Project No. 691

BWROG-02042
April 25, 2002

**SUBJECT: A REVIEW OF NUREG/CR-5750 IGSCC IMPROVEMENT FACTOR AND
PROBABILITY OF RUPTURE GIVEN A THROUGH-WALL CRACK**

GE-NE-A41-00110-00-1, Rev. 0
DRF # A41-00110-00
Class II
April 2002

Figure 2 Summary of Alternative Alloy Factor of IGSCC Improvement

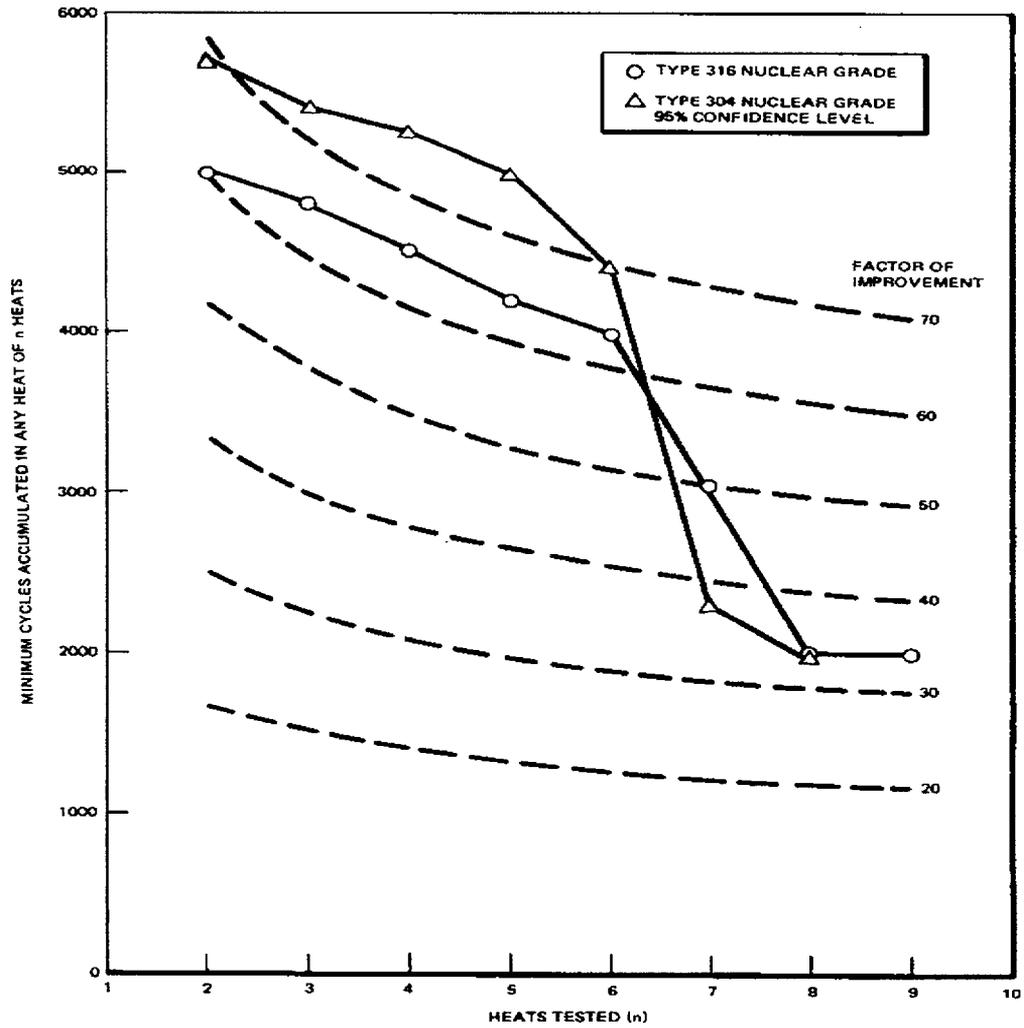
- Reference 2 reports on the FOI obtained for the alternate materials such as low carbon and nuclear grade stainless steels. The tests were conducted in 8 ppm oxygen environment. Figure 2 shows the FOI obtained from various heats of nuclear grade Type 304 and 316 stainless steels. It is seen that the FOI are in excess of 30 and reach a value up to 70 for some of the heats. It should be noted that the lower FOIs for some heats did not mean that there was IGSCC failure. It was simply test termination for specimen examination.

Figure 3 Leak and Break Probabilities for Reference Case – Small Pipe with Low Fatigue Stress and High Primary Stress – High Internal Pressure

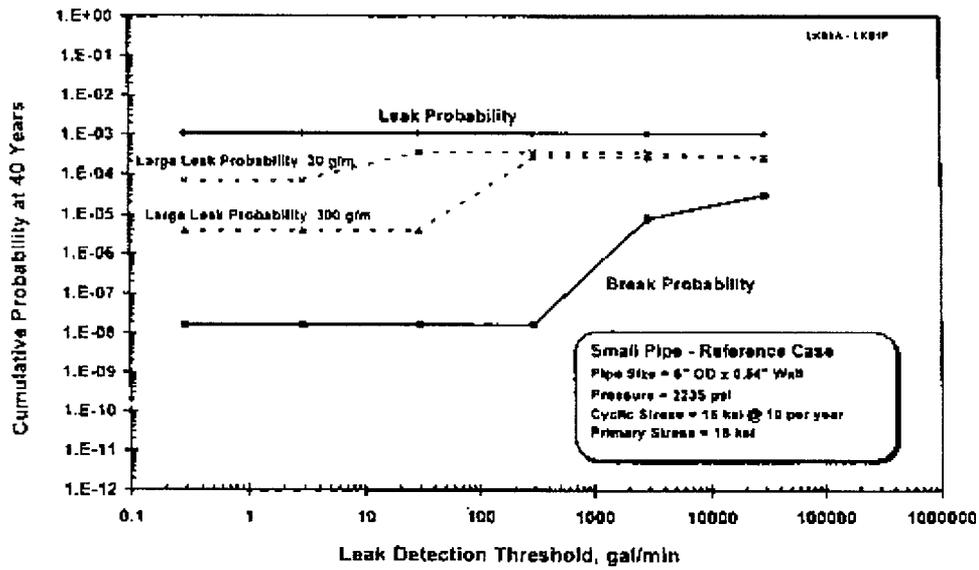
Figure 3 from Reference 7 presents the results for the calculated values of leak and break 40-year cumulative probabilities as a function of leak detection threshold for a 6-inch diameter pipe. The authors of Reference 7 used pc-PRAISE computer code to calculate the probabilities. The data at a leak detection threshold of less than 5 gpm are important for this discussion for the following reasons.

Figure 3 does not show a cumulative probability curve for 5 gpm leak case. However, from looking at the trend of the 300 gpm and 30 gpm leak curves, it is reasonable to assume that the 5 gpm leak curve would be very close to the upper solid line labeled 'Leak Probability'. In that case, there is almost four orders of magnitude difference between the leak and break probabilities. That means a $P_{R/TW}$ value of 1×10^{-4} . The differences between the leak and break cumulative probabilities for a 28-inch diameter pipe are even higher than those for the 6-inch pipe case.

Reference 7 considered only a fatigue mechanism and did not explicitly consider IGSCC. Currently no pc-PRAISE calculations are available in which a piping system with IGSCC remedial measures have been implemented. Nevertheless, it is judged that the $P_{R/TW}$ can be conservatively estimated as 1×10^{-3} if the calculations were conducted where IGSCC and the impact of remedial measures were considered.
